Response to Reviewer #2 on the manuscript:

*Using ICESat-2 and Operation IceBridge altimetry for supraglacial lake depth retrievals* by Fair et al.

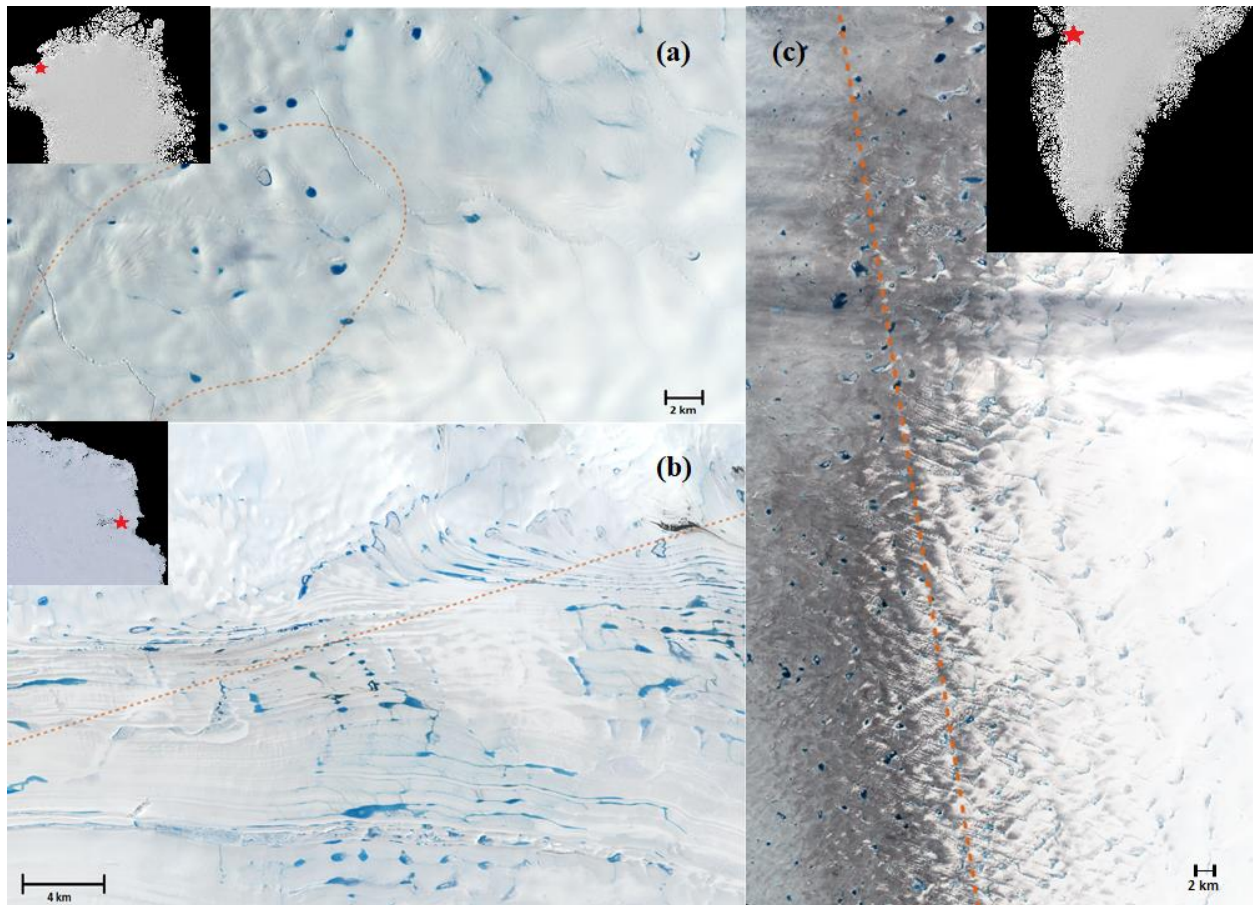
Figure 1: “Consider using dots to indicate location, rather than ovals, which are much larger than the image are?”

This is a good suggestion. We replaced ovals with stars centered on the regions of interest. The stars appeared small if the full continental image was used, so we cropped the images to center on the markers. The new figure may be seen below:

Figure 2. Schematic for the workflow of the lake surface-bed separation algorithm, where green boxes indicate data inputs and blue boxes are steps in the algorithm. Roman numerals match the steps given in Section 3.1.

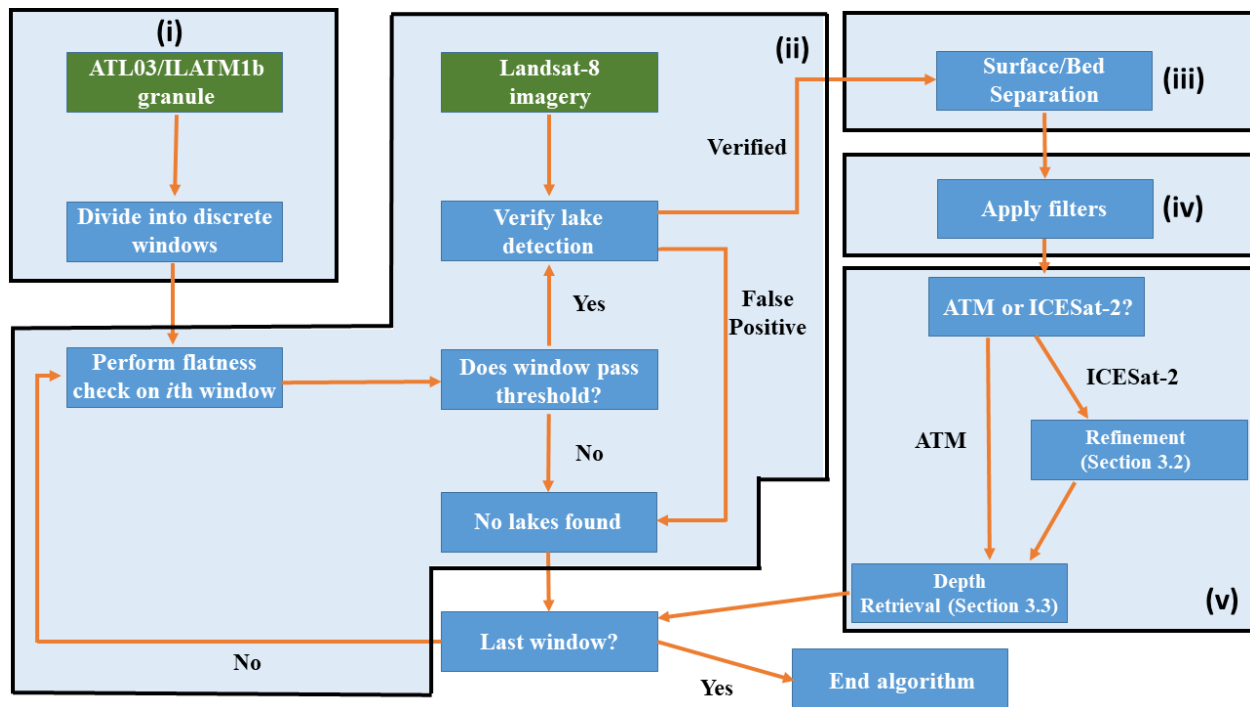
Page 4 / Section 3.1 in general: “It would be even clearer to present these methods if there were agreement between the steps here and in Figure 2 (e.g. one box / arrow per bullet point).”

Figure 2: “It is slightly confusing that you use the same blue boxes for both data and processes (e.g. Landsat 8 imagery vs verify lake detection), consider using different shapes / colors / some design choice to indicate the difference?”

We contemplated this suggestion, and we decided that one box or arrow per bullet point was unnecessary. However, we added labels to Figure 2 (now Figure 1 in response to another suggestion) to improve consistency with Section 3. The modified figure is shown below, and the bullet points in Section 3.1 were changed for consistency:

We changed the color of the “ATL03/ILATM1B granule” and “Landsat-8 imagery” boxes to green to differentiate data inputs from algorithm steps. We also grouped the steps into sections to create better consistency between the figure and Section 3, as suggested above. The new figure and caption are shown below:
